Access Compliance Report

Public Rights-of-Way

Intersection ID: 49397	Main Street: HERFORD_ST	Cross Street: DAMASCUS_ST	Location: NW
ADA ID: E9983FFBCD2D	Ramp Type: PerpDiag	Initial Pass/Fail: Fail	Overall Compliance: No
		Severity Score: 12.5

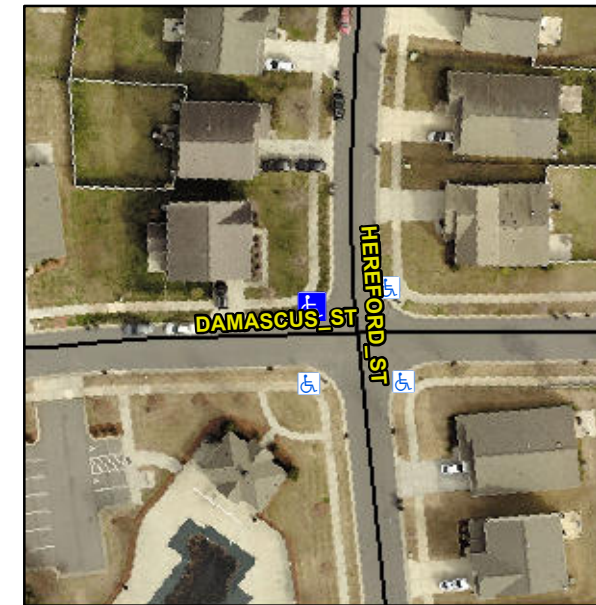
Not Found, R304.5.3

Compliance	Description	Data	Compliance	Description	Data
N/A	Ramp Length (in)	72.0	Yes	Ramp Slope (%)	5.4
Yes	Ramp Width (in)	48.0	No	Ramp XSlope (%)	6.4
N/A	Flare Type LT	N/A	N/A	Flare Type RT	N/A
N/A	Flare Slope LT (%)	N/A	N/A	Flare Slope RT (%)	N/A
N/A	Flare Traversable LT?	N/A	N/A	Flare Traversable RT?	N/A
N/A	Landing Length (in)	N/A	N/A	DWS Provided?	N/A
N/A	Landing Width (in)	N/A	N/A	DWS Contrast?	N/A
N/A	Landing Slope (%)	N/A	N/A	DWS Length (in)	N/A
N/A	Landing X Slope (%)	N/A	N/A	DWS Full Width?	N/A
N/A	Landing Curb? (Y/N)	N/A	N/A	DWS Offset (in)	N/A
N/A	Shared Landing?	N/A			
N/A	Gutter Ponding?	N/A	N/A	Gutter Slope (%)	N/A
N/A	Gutter Lip Ht (in)	N/A	N/A	Gutter X Slope (%)	N/A
N/A	Painted X Walk1?	No	N/A	Painted X Walk2?	No
	X Walk 1 Direction	To S		X Walk 2 Direction	To E
N/A	X Walk 1 Width (in)	N/A	N/A	X Walk 2 Width (in)	N/A
	X Walk 1 Slope (%)	2.3		X Walk 2 Slope (%)	0.7
	X Walk 1 X Slope (%)	0.5		X Walk 2 X Slope (%)	3.8

Remove & Replace Curb Ramp With Two New Directional Ramps or Equivalent.
